61 TRELLECK ROAD

RESPONSE TO PUBLIC COMMENTS

This document has been prepared as a response to public comments for planning application 211860 : 61 Trelleck Road.

Daylight analyses model in accordance with BRE guidance.

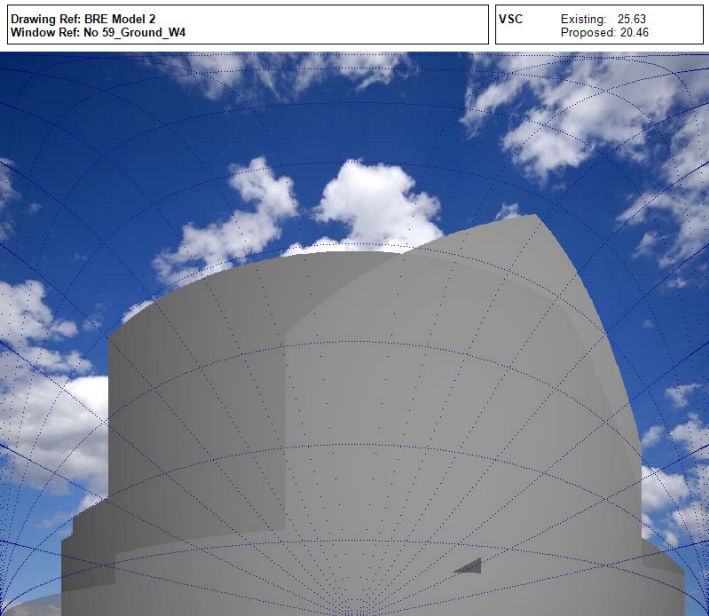
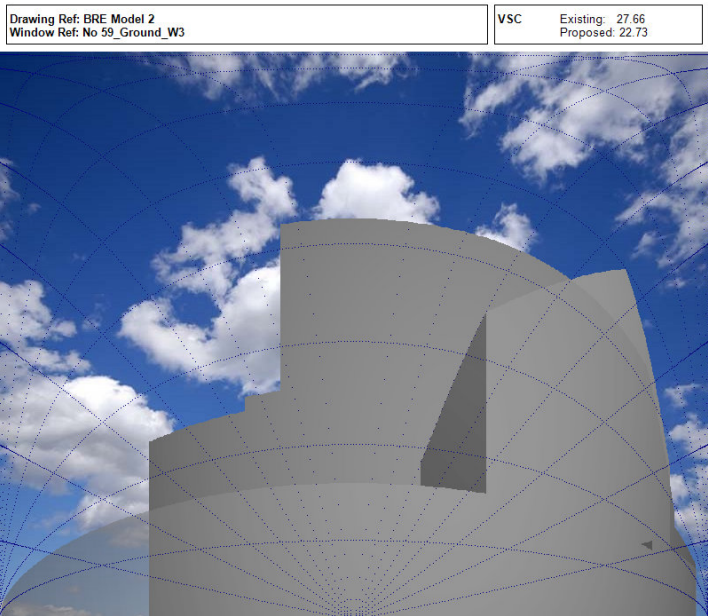
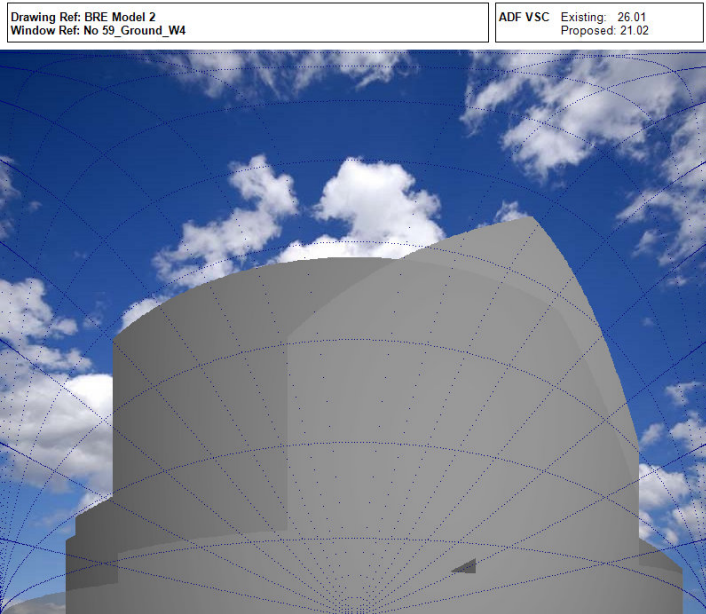
This will greatly reduce daylight in my main kitchen and landing windows.

3.1 Daylight reduction to Kitchen and Landing window it is within the accepted guidance of BRE second edition 2011: all values of the proposed development are above 80% of the existing values as demonstrated below.

Building Name	Floor Name	Window Name	Window Id	VscExisting	VscProposed	Pr/Ex	Meets BRECriteria	Window Orientation
No 59	First	W1	5	39.62	39.615589	1	YES	156°
No 59	First	W2	6	39.62	39.613268	1	YES	156°
No 59	First	W3	7	31.261418	30.519704	0.98	YES	246°
No 59	Ground	W1	1	38.856309	39.409983	1.01	YES	156°
No 59	Ground	W2	2	39.477538	39.363476	1	YES	156°
No 59	Ground	W3	3	27.663504	22.725862	0.82	YES	246°
No 59	Ground	W4	4	25.628259	20.456224	0.8	YES	246°

3.2 AIR SOURCE HEAT PUMP

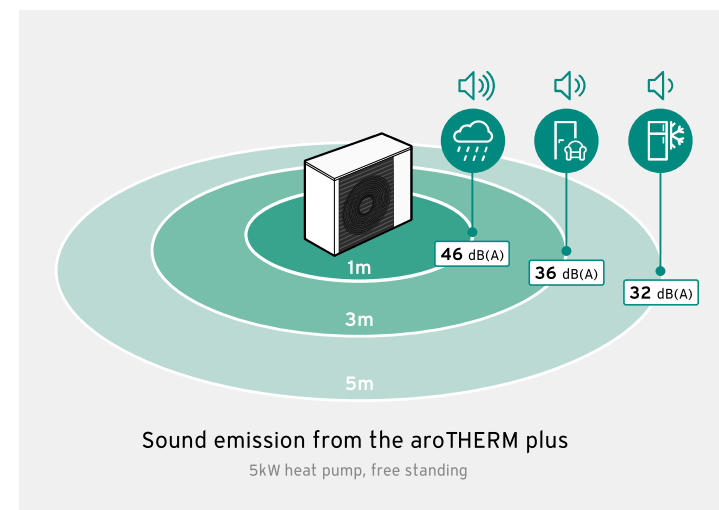
Regarding the Air Source Pump I am concerned about the noise, it is to be positioned near my boundary opposite my back door and will be heard from my garden.

The air source heat pump has also been moved from the roof to a wall mounted position in the back garden and has been encased in an acoustic casing as per Site plan SP 1.0
